1.0 Introduction

SLR Consulting Limited (SLR) has been appointed by Acorn Bioenergy Limited (Acorn) to provide consultancy services to support a Planning Application for the construction of a new AD Facility. This Transport Technical Note (TTN) provides further information relating to comments made by Wiltshire County Council Highway Development Control as acting Local Highway Authority (WCC Highways).

Planning Application Ref: PL/2023/03359

Proposal: Construction and operation of anaerobic digestion facility, ancillary infrastructure and construction of new access from Ashton Road

Proposed Site Layout

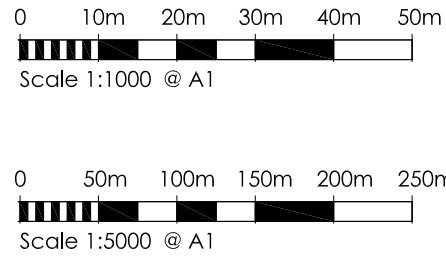
...It is mentioned that the site access gates will be set back sufficiently within the site, however details are required to ensure the gates are set back an appropriate distance to enable the largest length of vehicle to pull up to the gates and be clear of the highway, in the event that a vehicle arrives when the gates are unopened.

Provision for 6 parking spaces for staff and visitors is stated to be provided in the vicinity of the site office, although there is no detailed plan to indicate the parking location.

The drawing included at **Appendix 02** shows an updated proposed site layout with the proposed location of the gates added. The gates will be set back 22.2 metres back from the end of the kerb entry/exit radius, with adequate access road length to accommodate a maximum sized HGV clear of the highway.

The drawing included at **Appendix 02** shows an updated proposed site layout with the car parking arrangements marked. The proposals show 6 car parking spaces on the western edge of the site access corridor.

Updated to show Location of Gates and Car Parking

Feedstock Catchment Plan

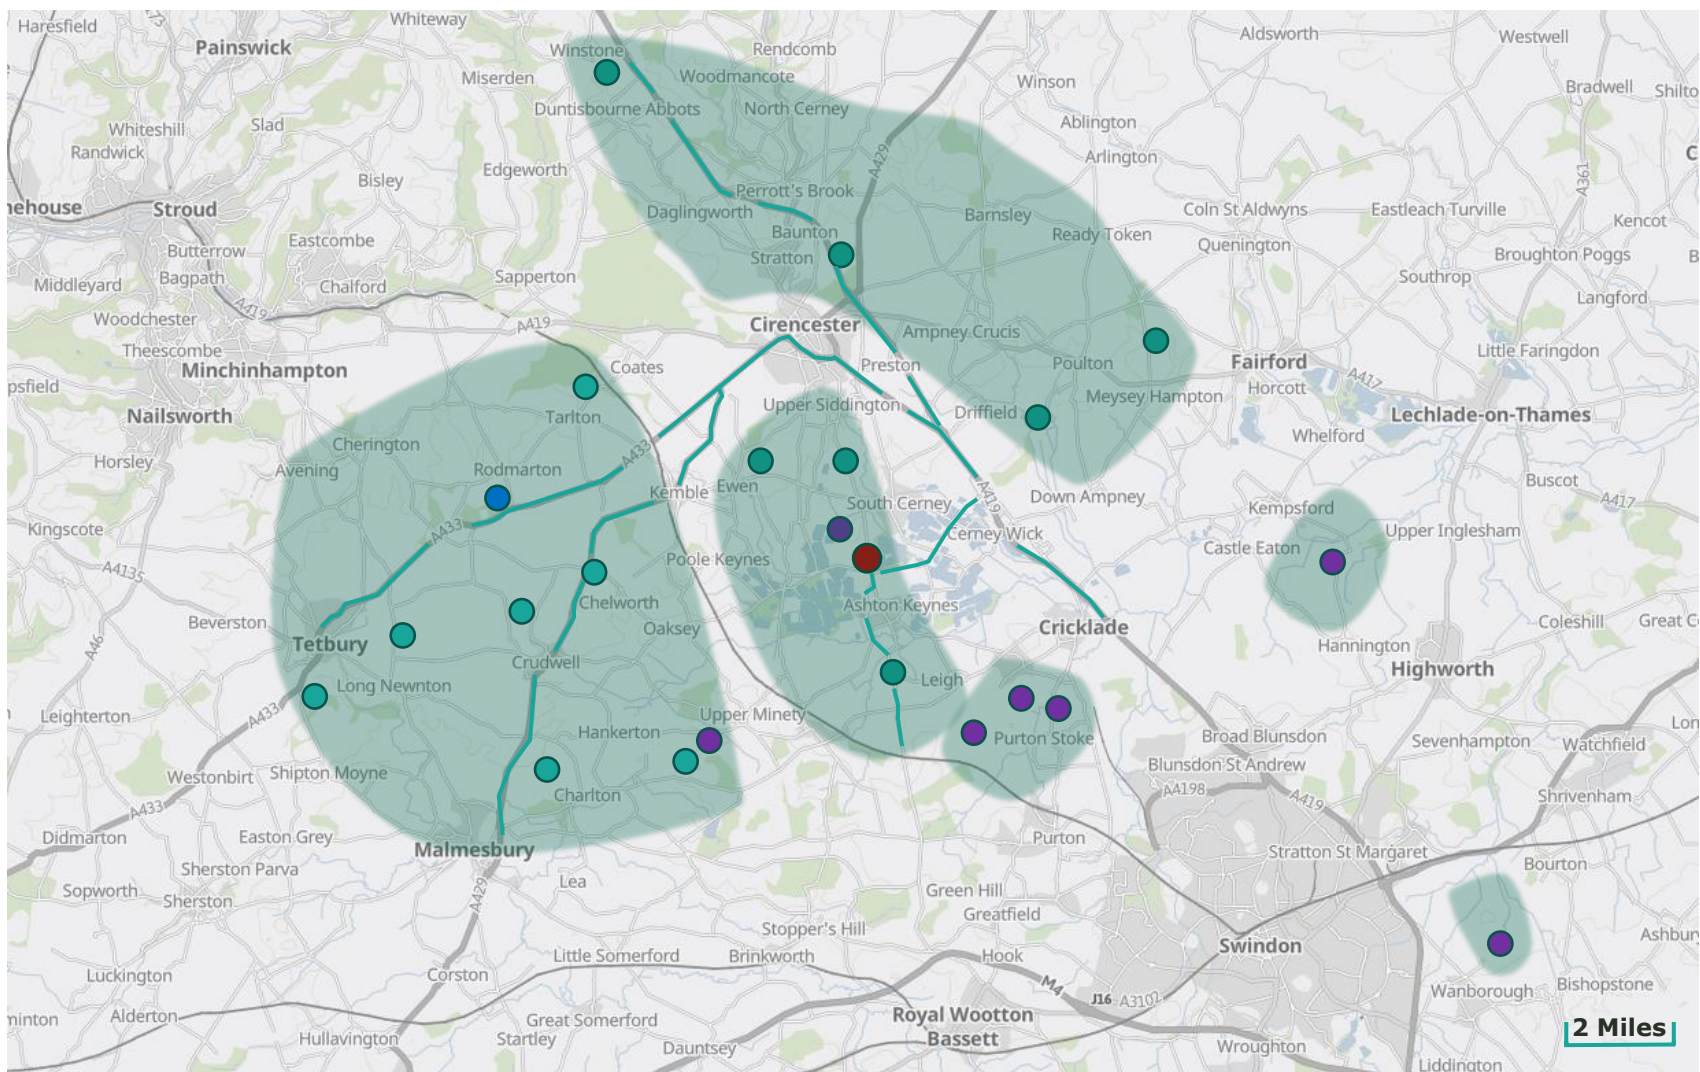
Having regard to the above, whilst the Wiltshire highway network serving the site would appear to have the capacity to accommodate the proposed development traffic and in compliance with appropriate traffic increase forecasts, I consider that more detailed information of the locations of the farms expected to use the facility is required to identify the routes likely to be used, and the impacts on the local areas.

The origin of feedstock and destination of byproducts is subject to contractual agreement. However, a plan has been provided by Acorn which shows the distribution of interested feedstock counterparties. This is attached at **Appendix 03**. The plan shows the proposal site for context and the likely primary traffic routes.
